From: Levin, Laxsamee
Sent: Tuesday, July 07, 2009 12:20 PM
To: KWills@Geosyntec.com; smccash@wasteservices.com
Cc: mkaiser@wasteservicesinc.com; Lubozynski, Tom; Heidorn, Marjorie; Williams, Elizabeth
Subject: RE: OCD-SW-09-0198 J.E.D. Class I Landfill WACS Facility I.D. 89544

On behalf of J.E.D./Waste Services of Florida, Inc., Geosyntec Consultants submitted the 9th Semi-Annual Water Quality Monitoring Report dated February 2009. The report was received on 2/9/2009. The report represents November 2008 sampling event. We reviewed the report. Our findings and comments are listed below.

Re: 7th Semi-Annual Water Quality Sampling Event
Oak Hammock Disposal Facility (OHDF)
Omni Waste of Osceola County, LLC
Permit Application Nos. SC49-0199726-004 and SO49-0199726-005

**Subject: Revise Location for Monitoring Well Cluster MW-23
Proposed Groundwater Monitoring Well Network for Phases 2 and 3
Oak Hammock Disposal Facility, Osceola County, Florida**

**PHASES 1 THROUGH 3
 GROUNDWATER MONITORING WELL LAYOUT**

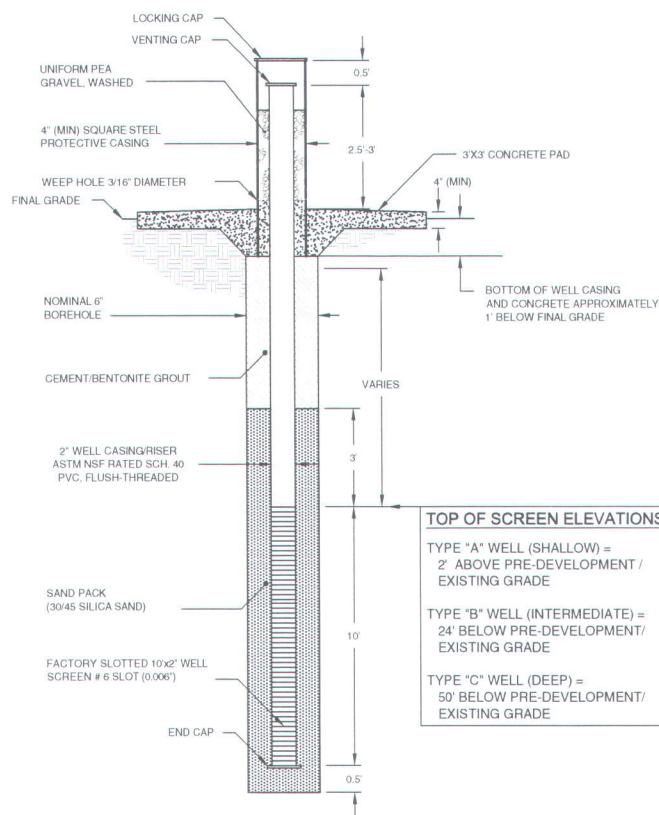
This letter is being submitted to FDEP to revise the location of monitoring well cluster MW-23. The revised location of MW-23 cluster is 200 ft directly north of the currently permitted location (see revised Sheet 24 of 40 of the Renewal Permit Drawings attached to this letter). In the revised location, MW-23 cluster will be approximately 600 ft south of the existing MW-1 cluster and approximately 1,000 ft north of the proposed MW-22 cluster. Monitoring well clusters MW-1, MW-22, and MW-23 are upgradient well clusters. It is noted that the spacing between these three upgradient monitoring well clusters (for the revised location of MW-23) is less than the spacing allowed by the Rule 62-701.510(3)(d)3.

Ayushman,
For the revised MW-23 location, the facility will need to submit a signed and sealed copy of Sheet 24 of 40 with the permitted and revised locations clearly noted. Please detail the reasons for the relocation.

REVISED LOCATION OF MW-23
 N 1355201.79
 E 623951.12

Figure 1
Chloride Concentrations Over Time in A Zone Wells

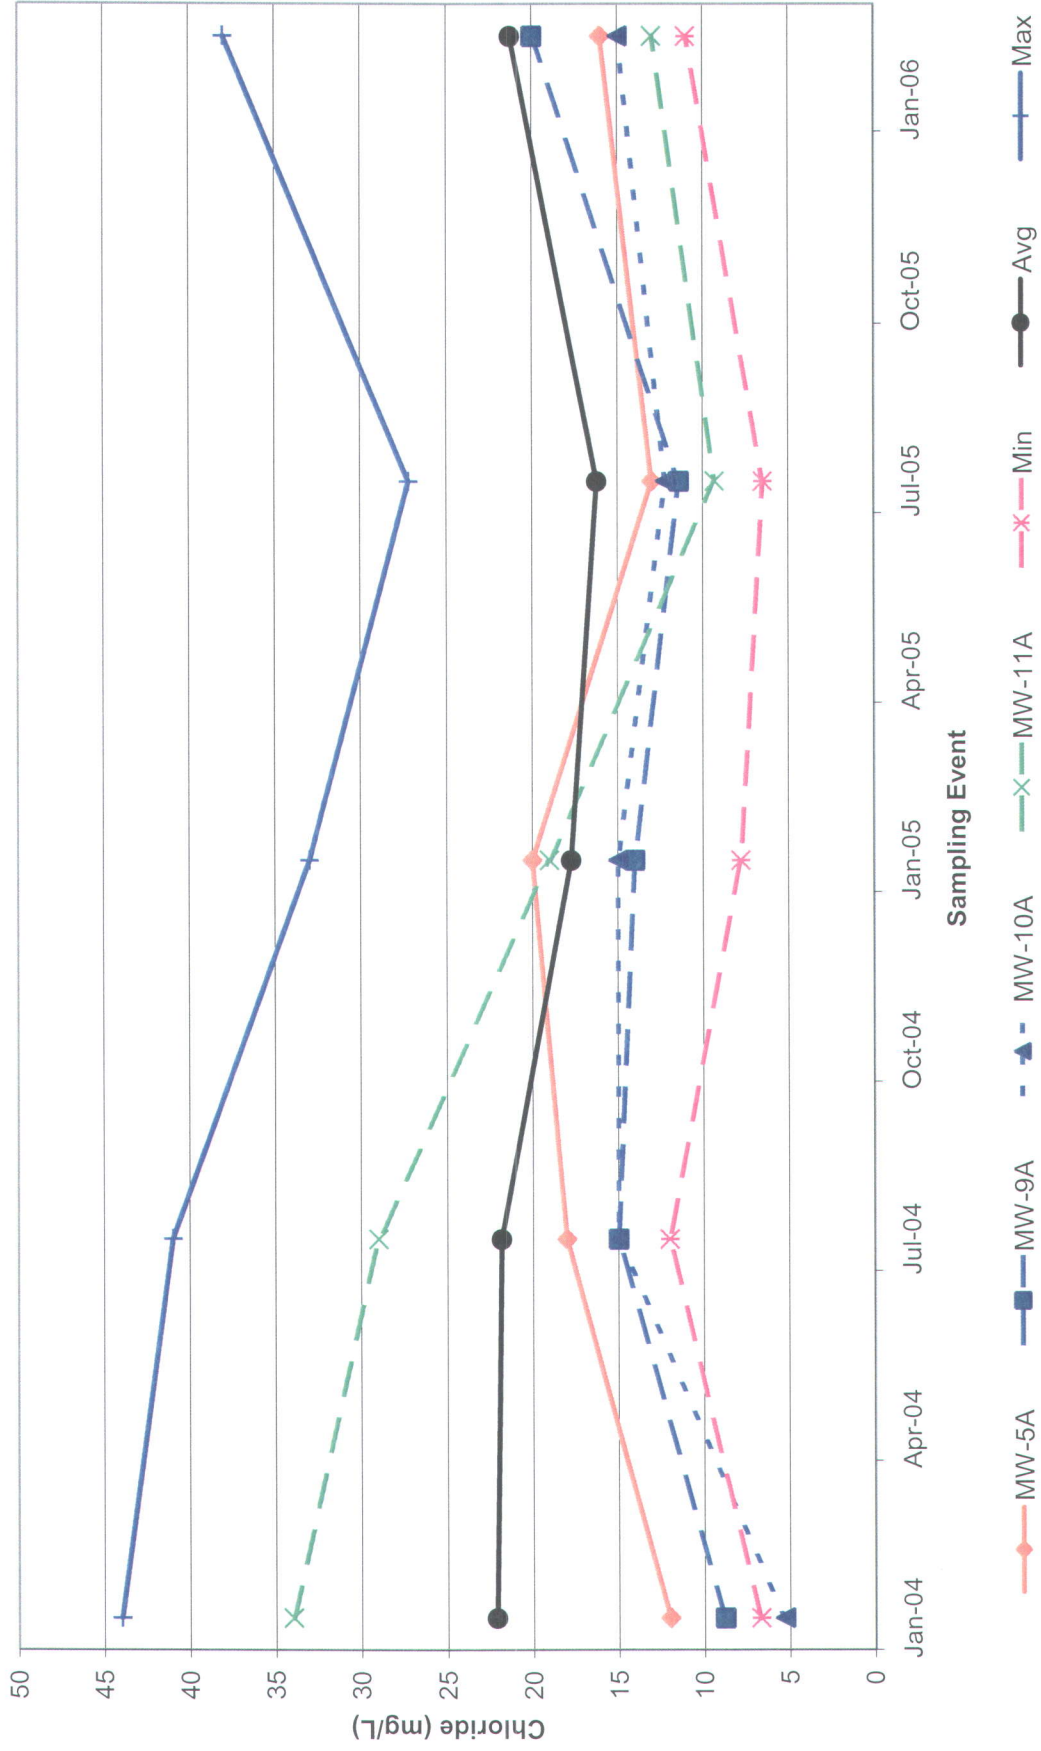
Comment 8. Offer possible sources for the ammonia exceedances in MW-5A and MW-9A, MW-10A, and MW-11A

Chloride and sodium levels in A Zone groundwater were evaluated for evidence of landfill impacts to groundwater. Chloride and sodium are inorganic constituents that are generally present at elevated levels in leachate and have been widely used as tracers for landfill impacts to groundwater. Figure 1 provides a summary of chloride concentrations reported in A Zone groundwater from the baseline event (January 2004), prior to liner installation and the acceptance of waste, to the February 2006 sampling event. The reported concentration of chloride for monitoring wells MW-5A, MW-9A, MW-10A, and MW-11A has been consistently less than the average chloride concentration and appear

to decrease over time rather than increase. If leachate were impacting groundwater, the chloride concentration would be expected to increase as the reported chloride concentration in leachate (2,300 mg/L during January 2006) is almost two orders of magnitude higher than background chloride levels. Sodium concentrations over time (Figure 2) also indicate a non-leachate source as the reported concentrations of sodium in monitoring wells MW-5A, MW-9A, MW-10A, and MW-11A are within the range of the site average with little to no change over time.
